Bulletin # SR-5H-005

## SERVICE BULLETIN

Ride Name: Hurricane

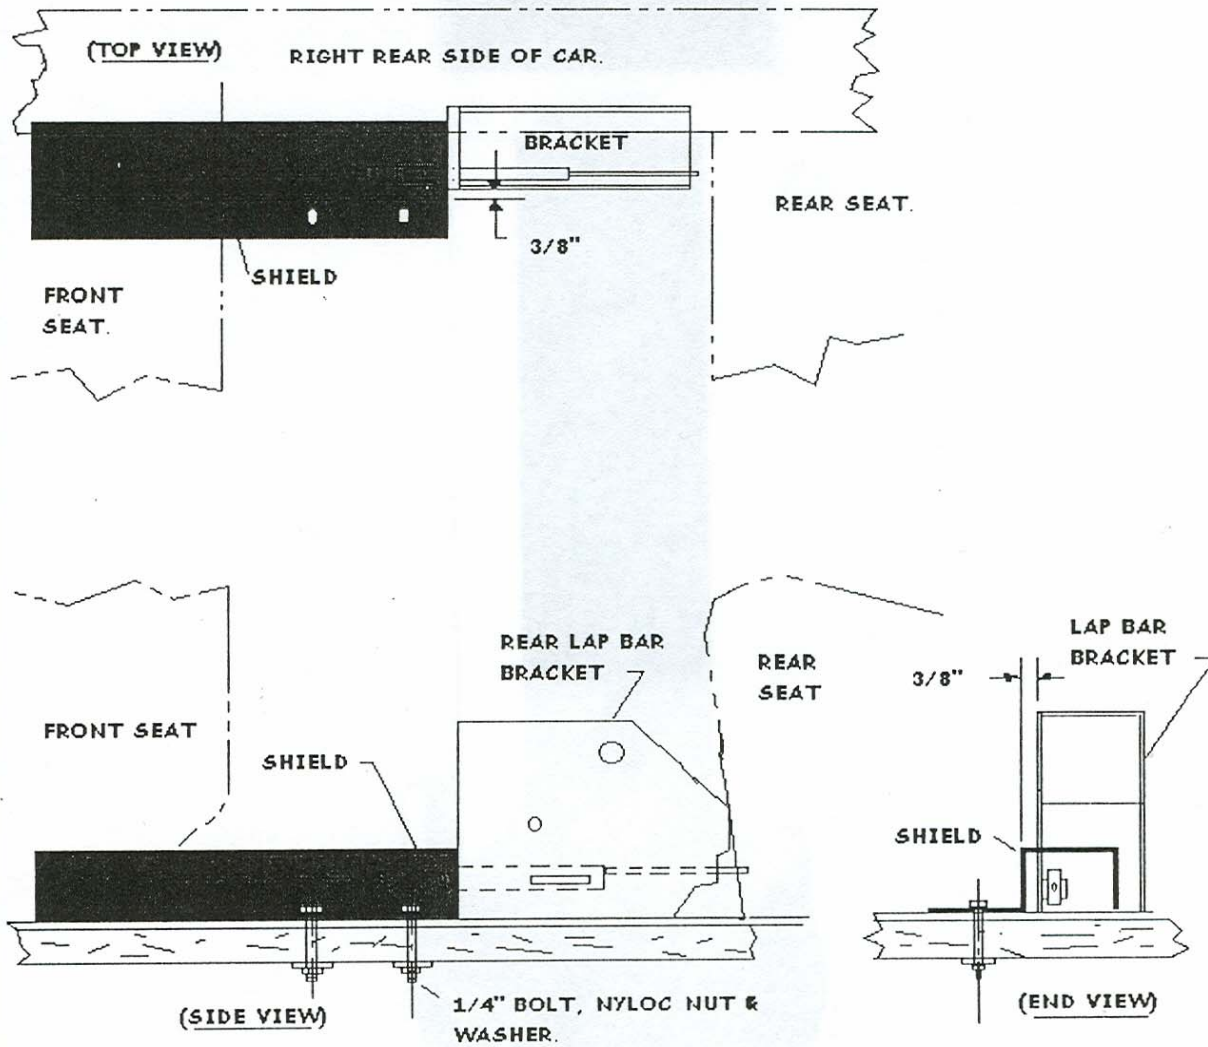
**Reason for release:** It may be possible for a passenger in the back seat to release one or both passenger restraints by using a foot to maneuver the restraint release linkage rod.

**Abstract of issue:** A shield provided by Dartron should be bolted to the car floor in such a manner that the rod is shielded from the hands and feet of passengers in the back seat of the car.

**Action to be taken:** A shield manufactured by Dartron **MUST BE** installed over the rear seat restraint release linkage rod by owners of Hurricane rides manufactured by Man-Co and Dartron.

**Installation:** Using the holes in the shield flange as a template drill 2 holes 17/64" diameter through the floor of the car. Install bolts, washers and locking nuts as shown below. Tighten bolts to no more that 100" lbs of torque. **CAUTION:** do not over tighten nuts. They should be snug and not dimple fiberglass. **SEE ATTACHED DRAWINGS**

POSITION THE SHIELD SO THAT IT IS AGAINST THE REAR LAP BAR BRACKET AND 3/8" OUT FROM THE FACE OF THE BRACKET. (AS SHOWN ABOVE)
